**RE: Cornish Library Addition  
Geotechnical Design Report Addendum No. 1  
Revised Slope Stabilization Measures**

This letter is an addendum to the geotechnical investigation report issued by TREK on February 1<sup>st</sup>, 2017 for the proposed Cornish Library addition at 20 West Gate in Winnipeg, MB. The addendum provides updated slope stabilization measures for detailed design.

Riprap at Bank Toe - approx. 1.1 m thick  
 GWL at approx. 2.5 m below ground surface  
 River Level at Elev. 224.0 m (RSRL)  
 Long-Term (Normal Summer)

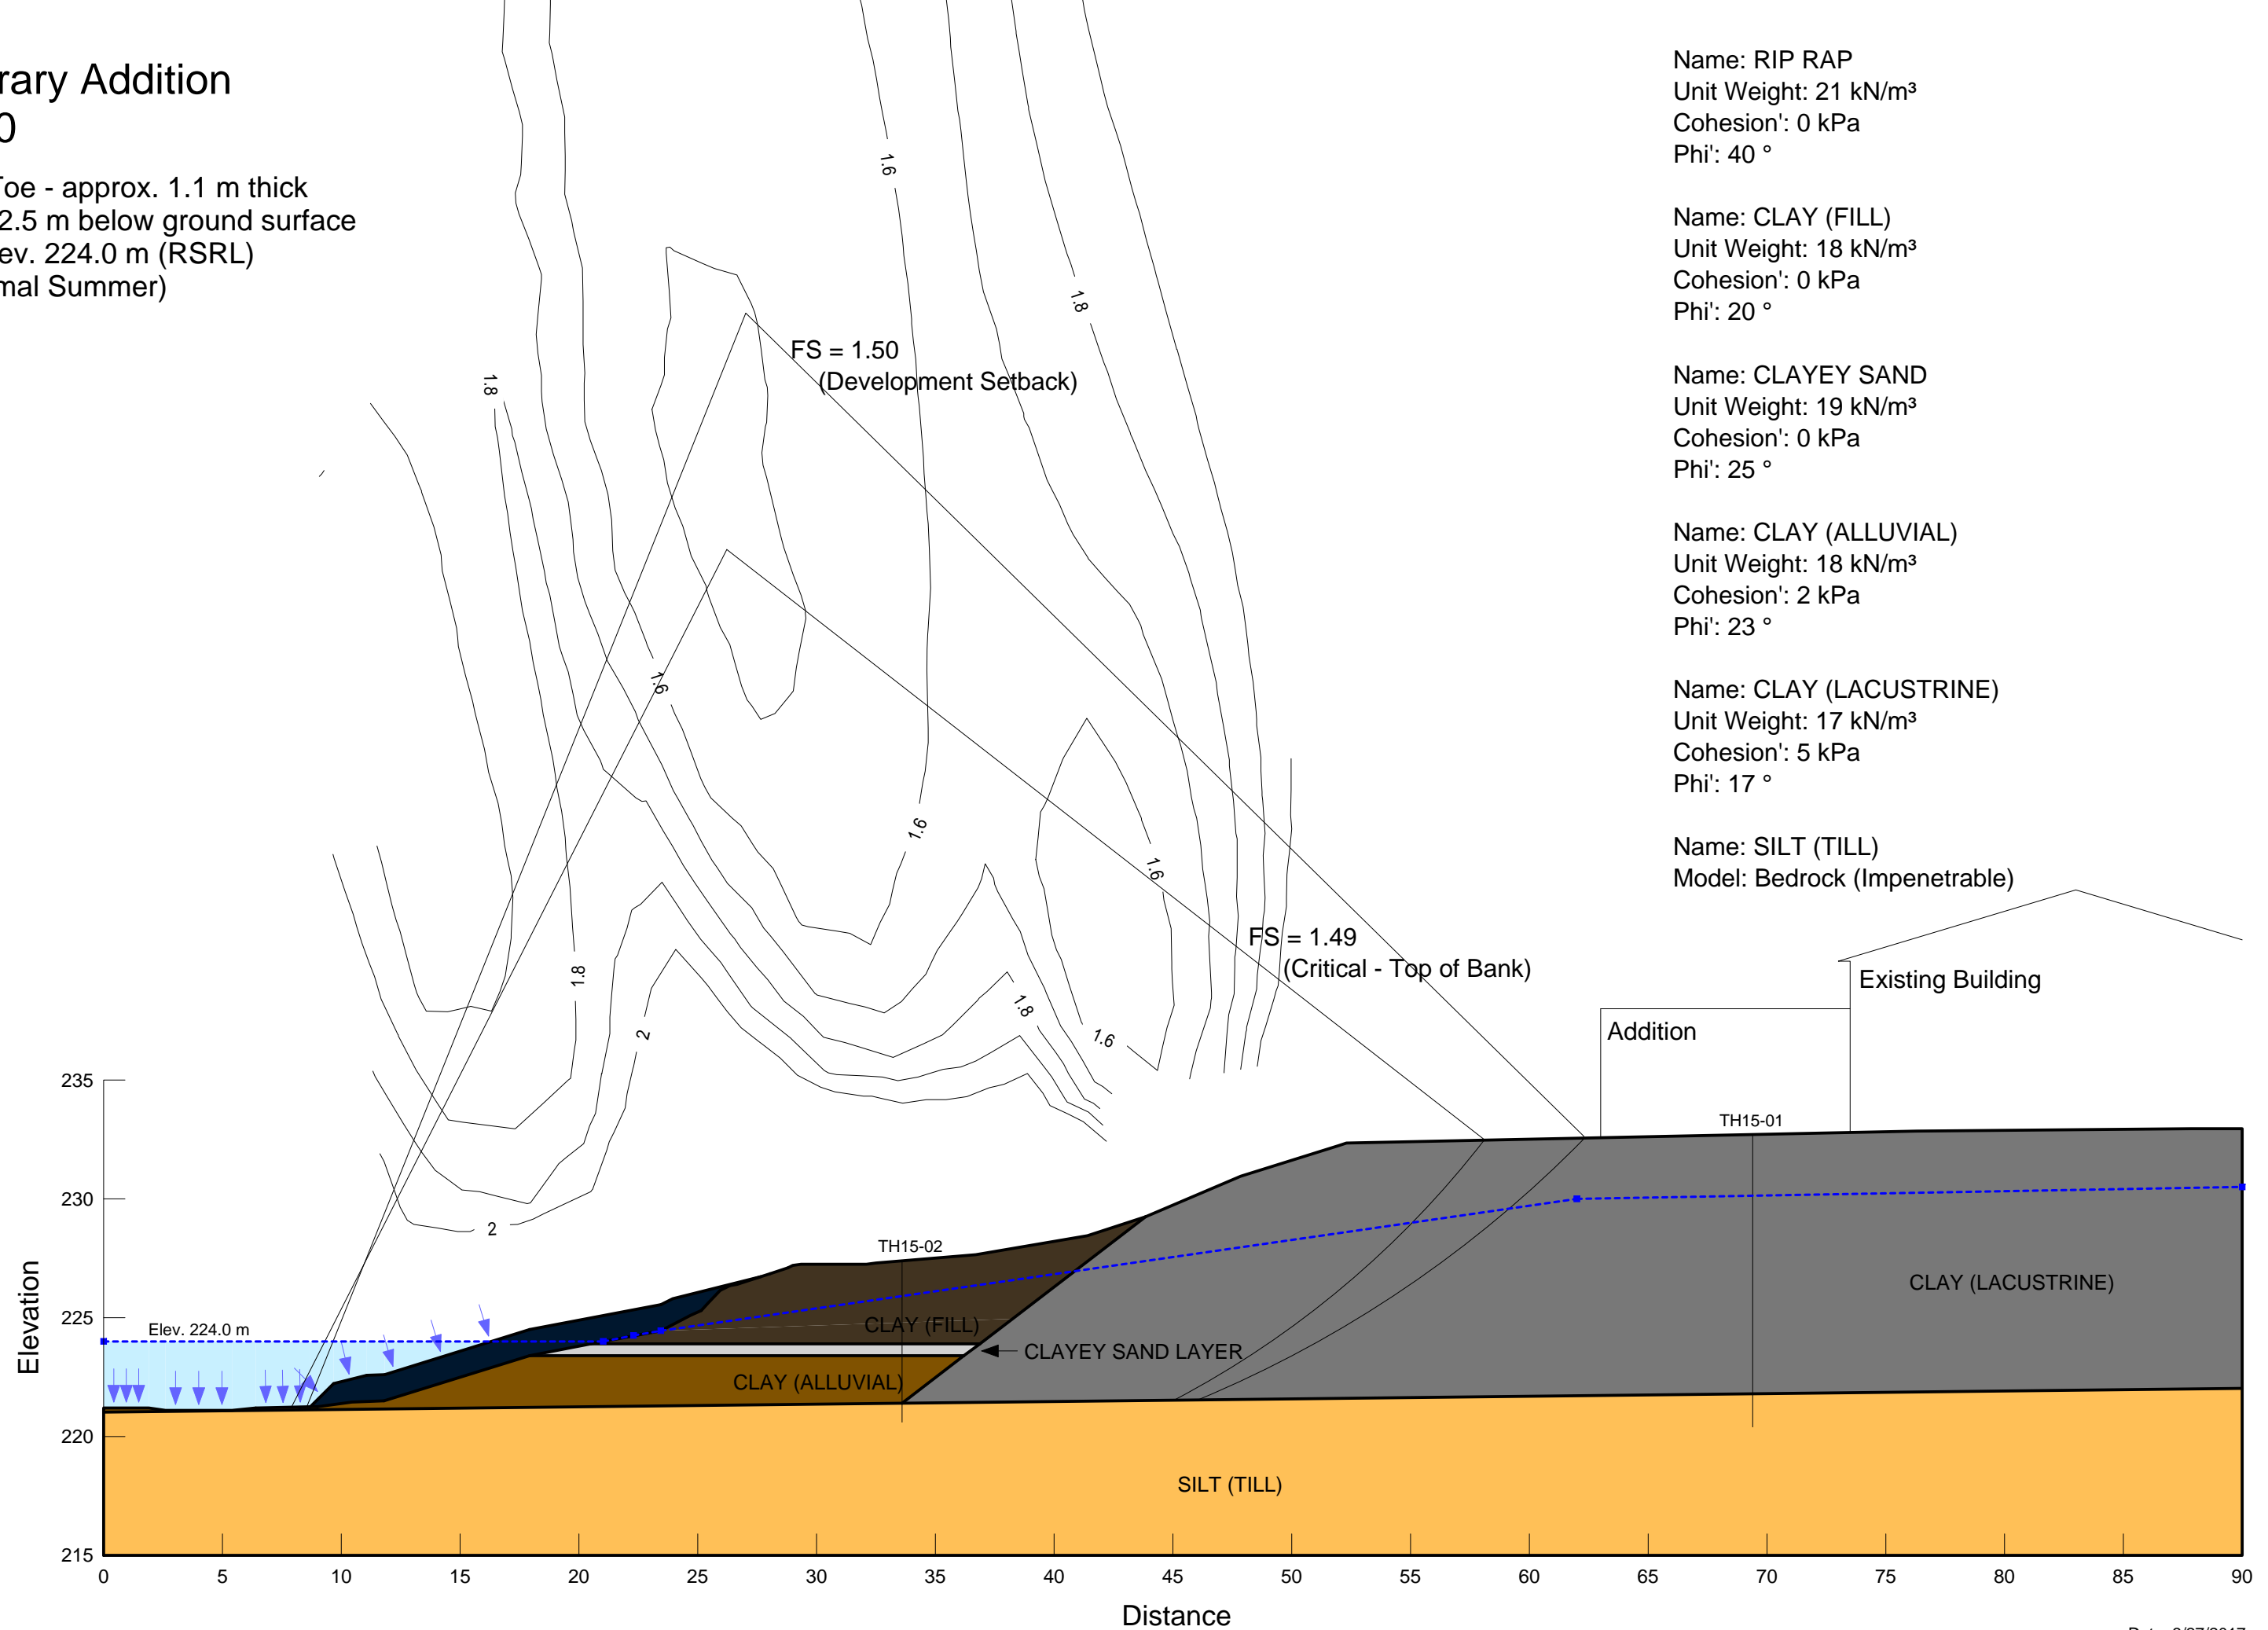
Stability analyses were performed to re-assess alternative riprap placement for detailed design. The soil stratigraphy, groundwater conditions, and numerical model described in the original geotechnical report were used in the re-assessment. To improve riverbank stability without re-grading the upper bank, the geometry of the riprap blanket was adjusted to achieve the target factors of safety for the short and long-term conditions. The results include a 1.1 m thick riprap blanket as shown in the attached figures.

A hydraulics engineer should be retained to review the proposed riprap geometry to determine the potential impact on the river levels and velocities as well as bank erosion of adjacent properties. A smooth transition of the riprap into the riverbank of the adjacent properties should be designed to avoid abrupt changes in geometry and minimize impacts.
